Subject: AP1000 COL Response to Request for Additional Information (TR #3)

In support of Combined License application pre-application activities, Westinghouse is submitting responses to NRC requests for additional information (RAI) on AP1000 Standard Combined License Technical Report 3, APP-GW-S2R-010, Rev. 0, Extension of Nuclear Island Structures Seismic Analysis. These RAI responses are submitted as part of the NuStart Bellefonte COL Project (NRC Project Number 740). The information included in the responses is generic and is expected to apply to all COL applications referencing the AP1000 Design Certification.

Response to Requests for Additional Information on Technical Report No. 3

RAI-TR03-021 and RAI-TR03-023

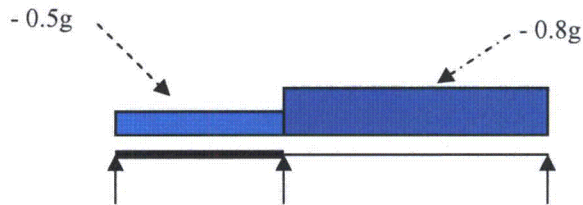
- b. The last paragraph of page 91 of 154 states "For those local flexible structures that are amplified, apply an additional acceleration to these structures equal to the difference between the average uniform amplified component accelerations and rigid body component equivalent static accelerations. These accelerations are to be considered in local design of the flexible portion of the structure but do not need to be considered in areas of the structure away from the local flexibility. They can be applied in a series of individual load vectors." It is not obvious to the staff how this methodology has been implemented, and whether the effects of increased accelerations on locally flexible structures can be ignored in areas of the structure away from the locally flexible structures. The sum total of all the flexible masses times the corresponding acceleration increments may impose non-negligible additional loads on the overall structure, in the two horizontal directions and in the vertical direction. Therefore, Westinghouse is requested to (1) describe in greater detail the implementation of this methodology, including a numerical example; and (2) provide a quantitative technical basis for the conclusion that the effects of increased accelerations on locally flexible structures can be ignored in areas of the structure away from the locally flexible structures.

The methodology being used allows the analyst the ease of applying the inertia loads by first applying the seismic accelerations using the accelerations of the associated structure as if it is not flexible. Then, using an additional load case, apply the incremental acceleration to the flexible portion. This procedure is shown below using a simple two span beam with three supports and one flexible area. This structure is subjected to vertical seismic excitation. The equivalent static acceleration for the beam at this elevation is equal to 0.5g vertical, and the flexible area has an average uniform vertical seismic acceleration of 0.8g.

The following load cases are considered in this example with the vertical load being down. Other, cases of course would be with the vertical excitation up.

Load Case 2: This load case is applied only to the flexible area. The inertia loading is the incremental portion above 0.5g that will act only on the flexible area ($0.8g - 0.5g = 0.3g$). It is noted that there are separate load cases for each of the flexible floors so that worst loading on the structures away from the flexible areas is obtained.

The results of the local load cases are combined absolutely with the results of the "rigid" portion in the same direction. The three directions are then combined by SRSS. The resultant member forces, that includes the "rigid" portions, reflect the total seismic inertial load on the structure.

Therefore, the effects of increased accelerations on locally flexible structures are not ignored in areas of the structure away from the locally flexible structures.

Figure 6.4-1 - Locations used for Comparison at Elevation 107'

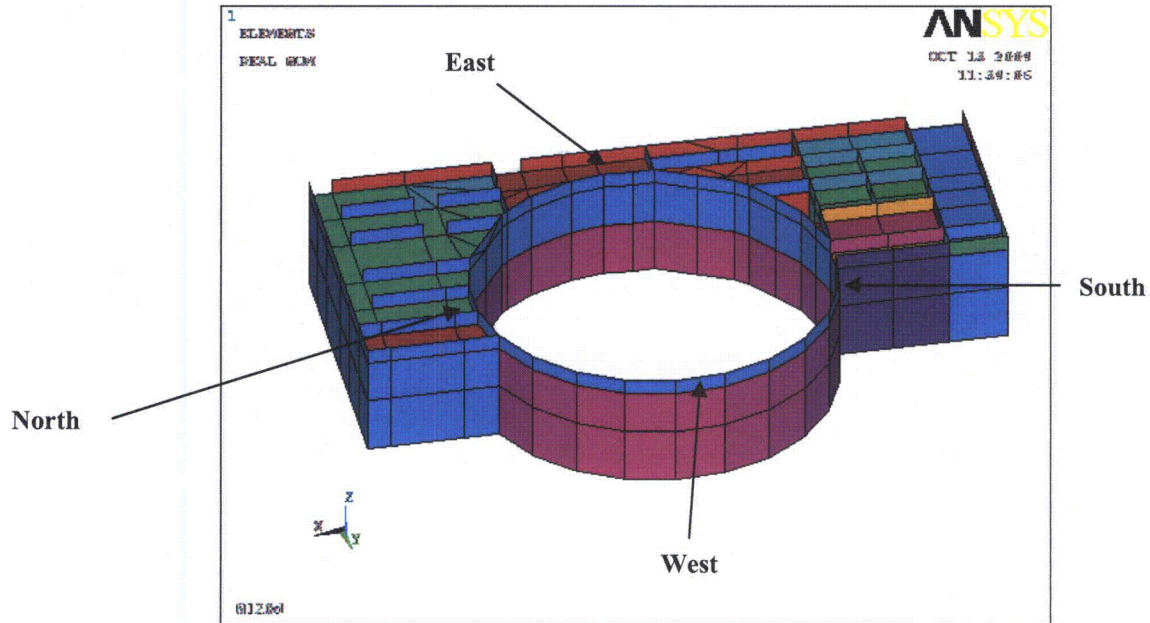
- a. A comparison of equivalent static acceleration results to the worst-case time history results is presented for a small number of selected locations. It is not clear to the staff why these specific locations were selected for comparison, and whether they are representative of all other locations in the structural model. Therefore, Westinghouse is requested to (1) explain the basis for selecting these specific locations for presentation in the report, and (2) confirm that a comprehensive comparison was conducted in order to validate that the equivalent static acceleration results generally envelop the worst-case time history results, and that any under predictions are minor.

- b. The staff noted that the only significant under-prediction documented in Section 6.4 is for TY at ASB south elevation 107 ft. The equivalent static result is 76.7 ksf; the worst time history result is 89.5 ksf. This represents a 15% under-prediction. Please discuss whether this is the maximum under-prediction identified. If not, please explain the criteria applied to justify the acceptability of under-predictions, in reaching the conclusion that the equivalent static acceleration method of analysis provides an acceptable basis for structural design.

- a. The locations were selected to provide comparisons at representative locations throughout the nuclear island where there would be significant member forces. Some were selected close to the base of structures where seismic loads would be maximum. For the shield building, elements were selected just above the interface of the cylinder and the dish at elevation 107' and on the cylinder at elevation 211'. Three structures within the containment internal structure were selected: refueling canal south west wall; south wall of west steam generator compartment; and north east IRWST wall (CA02). These are the walls selected as critical sections for which results are given in subsection 3.8.3.5.8.1 of the DCD. Three locations in the

auxiliary building were selected at elevation 107' and 135'. The locations are considered representative of the behavior throughout the nuclear island. Results for these locations have been added to the revised section.

- b. Other locations of under predictions were identified and discussed in part (a) of this RAI using the NI20 model for both the equivalent static and time history analyses for the rock case. The equivalent static acceleration results compare reasonably with those from the time history analyses particularly at the locations of maximum member forces that control the design. Therefore, the use of seismic equivalent static accelerations is acceptable.
